APPLICATION NO: 22/01441/FUL		OFFICER: Miss Michelle Payne
DATE REGISTERED: 10th August 2022		DATE OF EXPIRY : 5th October 2022
WARD: Pittville		PARISH:
APPLICANT:	Mr and Mrs Leach	
LOCATION:	10 Selkirk Street Cheltenham Gloucestershire	
PROPOSAL:	Erection of 1no. three storey self-build dwelling on land adjacent to 10 Selkirk Street

REPRESENTATIONS

Photo of proposed development site as viewed from Stanbrook House showing already extensive infill building in what was formerly rear gardens. The one mature tree seen here would no longer be visible from this vantage point if permission were granted to erect a 3-story building on the proposed site.

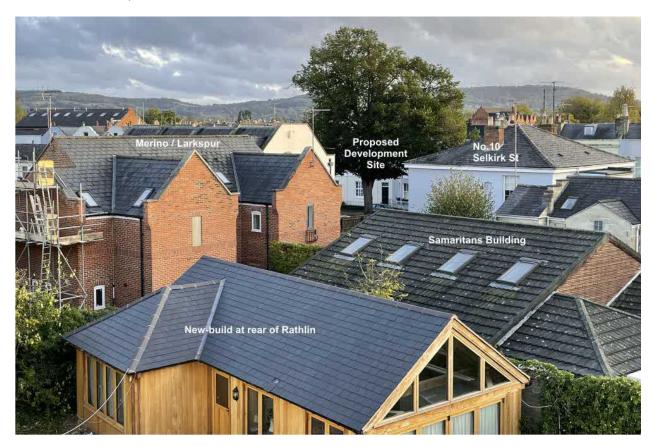
<u>Overdevelopment</u> – as can be clearly seen from the appended photograph, the proposed development at 10 Selkirk Street would obliterate one of the last remaining plots of non-built up land in an area that once almost entirely comprised open-space town gardens. The photograph is telling. Inappropriate overdevelopment has already wiped out much of this former green-space. Infill of the remaining tract of land adjacent to 10 Selkirk Street would be a clear breach of the Council's environmental objectives and obligations. The proponent's claim that this is currently a brownfield 'wasteland' of no environmental value is a non-sense. The site is only semi-derelict because the current owner has failed to maintain and improve it.
